MODEL: 2009 ~ 2012 Concours™ 14 & 14 ABS MODIFIED BY BEAUDRY MOTORS, INC. & BMS, INC. FOR LAW ENFORCEMENT USE (ZG1400A9F/L, B9F/L, CAF/L, DAF/L, CBF/L, CCF/L)
TITLE: CONCOURS 14 & 14 ABS MAIN FUSE & WIRING

RECALL

Subject

Inspect Factory Battery:

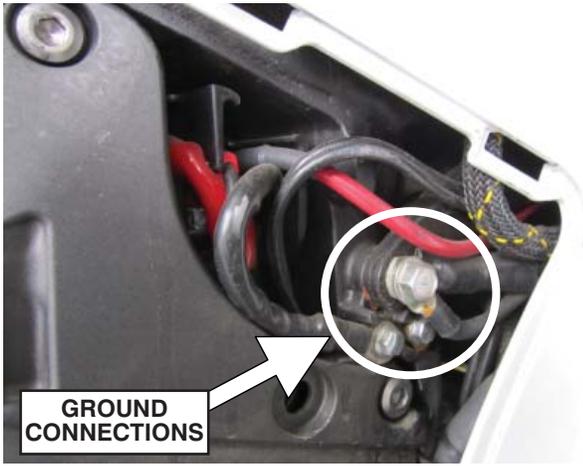
- Check the battery for bulging or heat damage and replace if required.

Inspect MNSTAR Wire Harness:

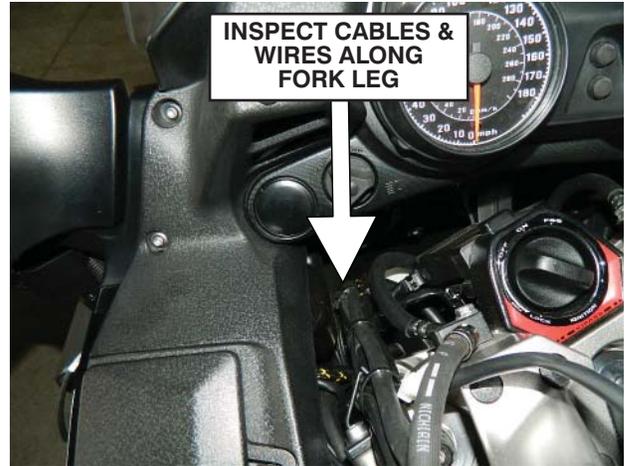
- Remove the fuel tank and discard the two forward mount bolts.
- Inspect the exposed portions of the MNSTAR wire harness (black with yellow stripe) for damage.
- Repair the MNSTAR wire harness as required.
- Install the shims in the Shim Kit (p/n 99969-3105) between the fuel tank and the two forward fuel tank mount points during reassembly. Use the new (longer) bolts included in the kit.

Inspect Cables/Wires Near Fork Tubes:

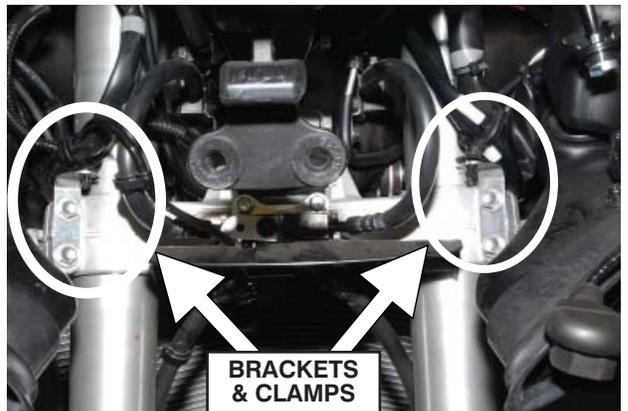
- Inspect the cable/wire routing from handlebar, down along fork tubes for damage. Repair and replace cables/wires as required.

- Remove the cable clamp and bracket from the left and right lower-outside triple clamps.

- Re-install triple clamp bolts and tighten to 30 N·m (3.1 kgf·m, 22 ft·lb).
- Secure cables and wires to prevent damage and binding when handlebar is turned stop-to-stop.

Replace Main Fuse:

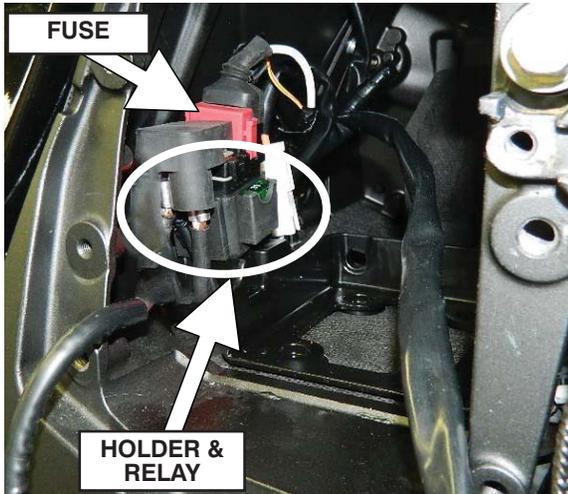
- Remove and replace the 30A main fuse (part number 26006-1080).
- Inspect the fuse holder/starter relay for damage or evidence of overheating. Replace as required.

- o *Replace the fuse regardless of its appearance.*
